Re: Docket No. 461 - CSC 461 Greenwich Substation and Line Project

Response to CSC-01 Interrogatories dated 07/30/2015

CL&P dba Eversource Energy
Docket No. 461

COS COB
 PLAN & SECTIONS
 CONNECTICUT SITING COUNCIL
 GREENWICH, CT

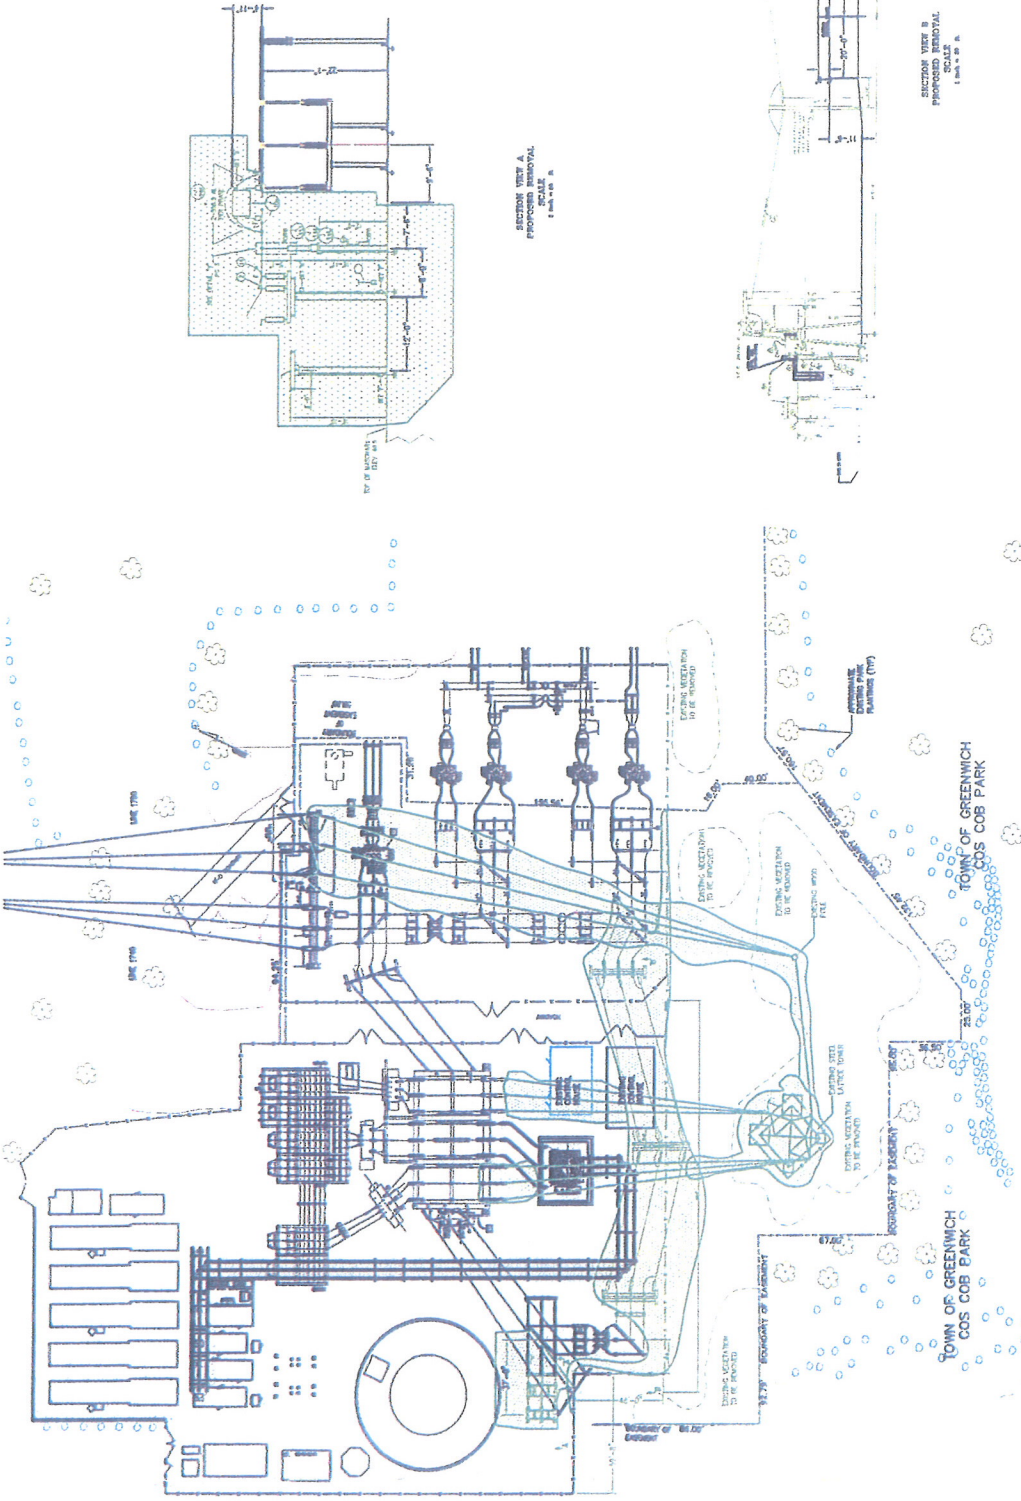
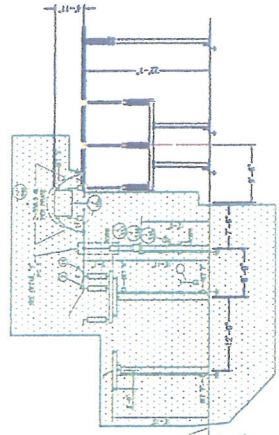
Please resubmit Application Appendix C, Cos Cob Site Plans, with appropriate substation component labels/property lines/vegetation as the plans submitted are difficult to read.

Please see the attached updated Appendix C, Cos Cob Site Plans.

Proposed Power Line Cos Cob Substation to Greenwich Substation		Cornerstone
Page 3 of 4	DRAWN BY: CS	SCALE: 1" = 200'
DATE: OCT 03, 2014

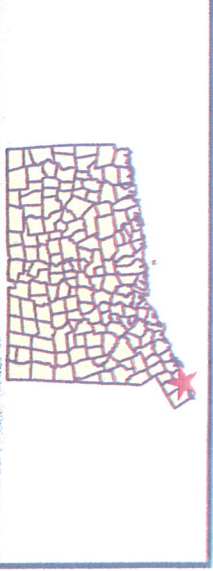
Regarding Application Appendix E, what proposed Eversource transmission line routes correspond to the routes listed in the DOT's letter? (the attached maps are illegible) . Has the DOT indicated a preference for any of the proposed transmission line routes?

The transmission line routes listed in the ConnDOT letter in Appendix E of the Application are the routes identified as North Easement, Variation 1 – South Easement, and Variation 2 – Middle Easement in the Overhead Metro-North Railroad Corridor sub-section of Section H.4.1, Overhead Routes Considered and Rejected, of the Application. Attached are more legible copies of the maps that are attached to the letter in Appendix E.
